Review of Long-Term Maintenance Plans for the South Jetty, Grays Harbor, Washington

*by Special Subcommittee of the Committee on Tidal Hydraulics and
Coastal Engineering Research Board*

Final report

**Prepared for U.S. Army Engineer District, Seattle
Seattle, WA 98124-2255**

Figure 20. Direct beach nourishment alternative

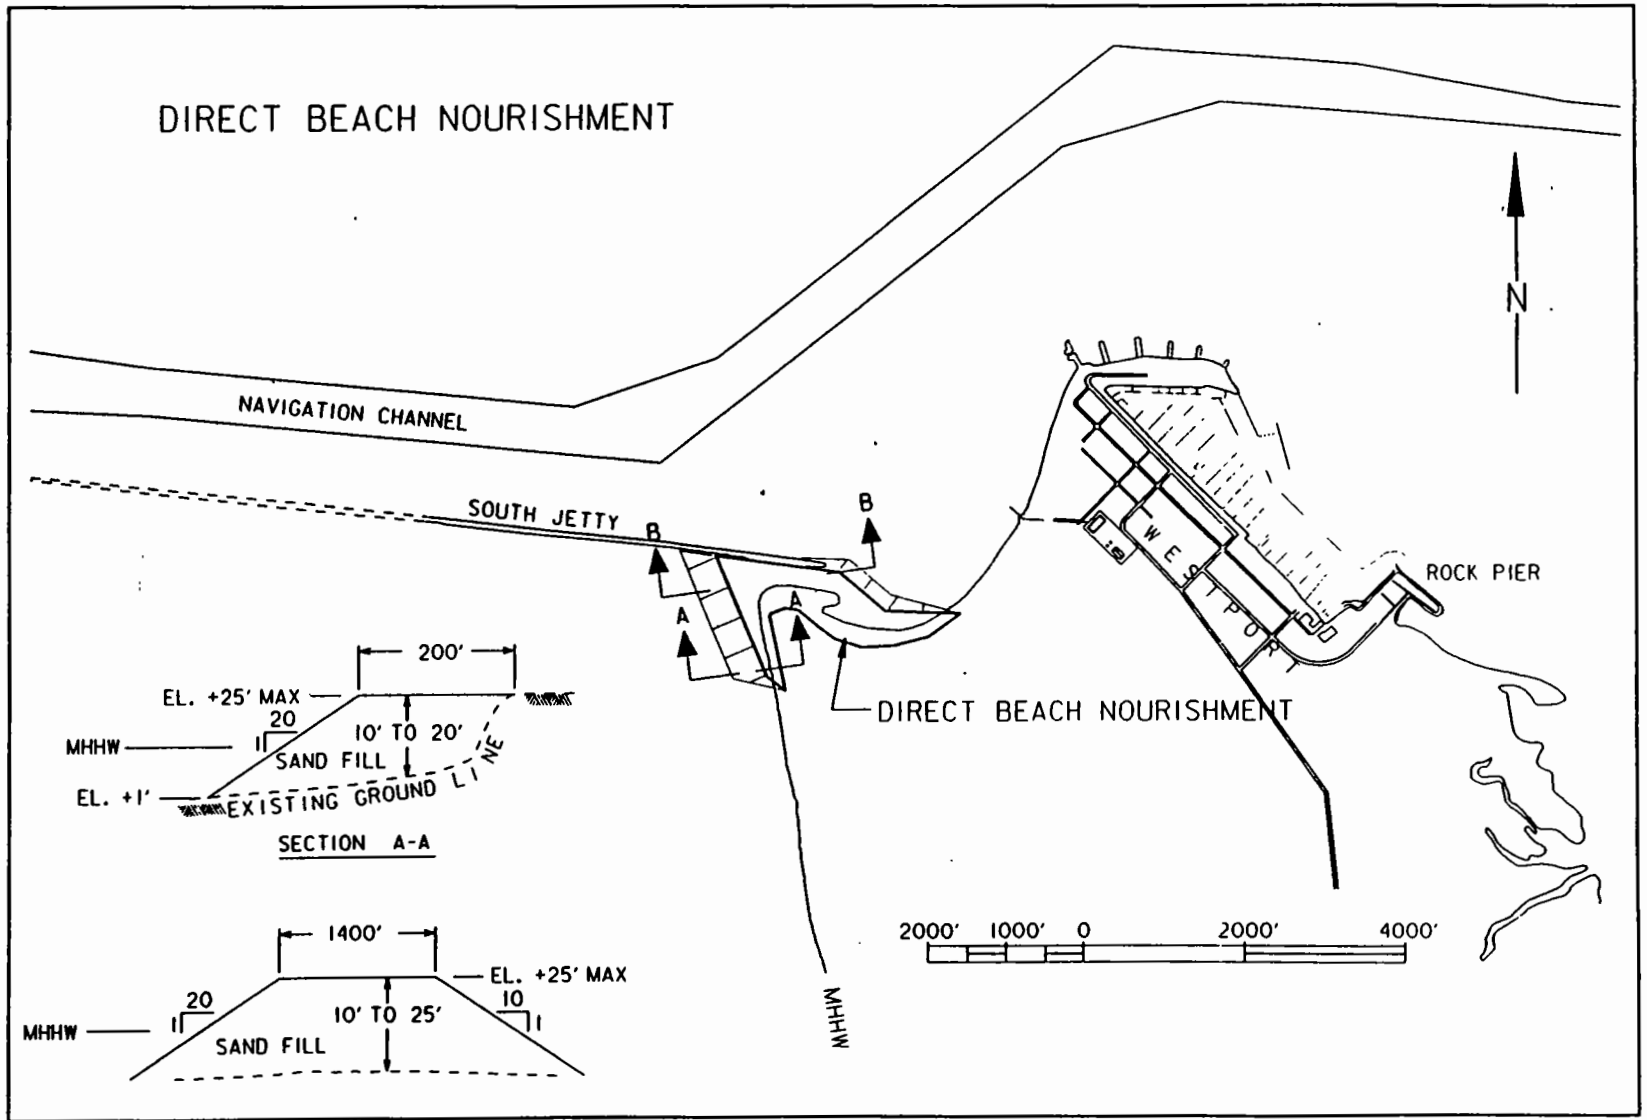
51. Placement of dredged material directly on the beach in the breach area as shown in Figure 20. The elevation of the top of the fill would be above that of the jetty to reduce the prospect of overtopping and to allow for settlement, and the width in the direction of the breach would be nearly twice that of the pre-breach sand neck. The eastern edge of the should extend from the eastern end of the jetty as shown in Figure 20 to protect the park facilities from erosion by waves diffracted by the end of the jetty. Approximately 500,000 cy of suitable material is dredged annually from the Entrance, Pt. Chehalis, and South reaches that could be placed at this location at a cost of \$4 to \$5 per cubic yard above present maintenance costs. The quantity of material dredged from these reaches is becoming smaller each year as the system adjusts to the 1990 channel modifications. Additional material, in diminishing amounts, is dredged from the bar, but the cost of transporting it to the beach would be prohibitive. Timing of this alternative is subject to fishery concerns, dredging schedules, and weather. To be a viable long term solution, this alternative would require a commitment to supplement sand from diminishing maintenance dredging with material dredged for nourishment.
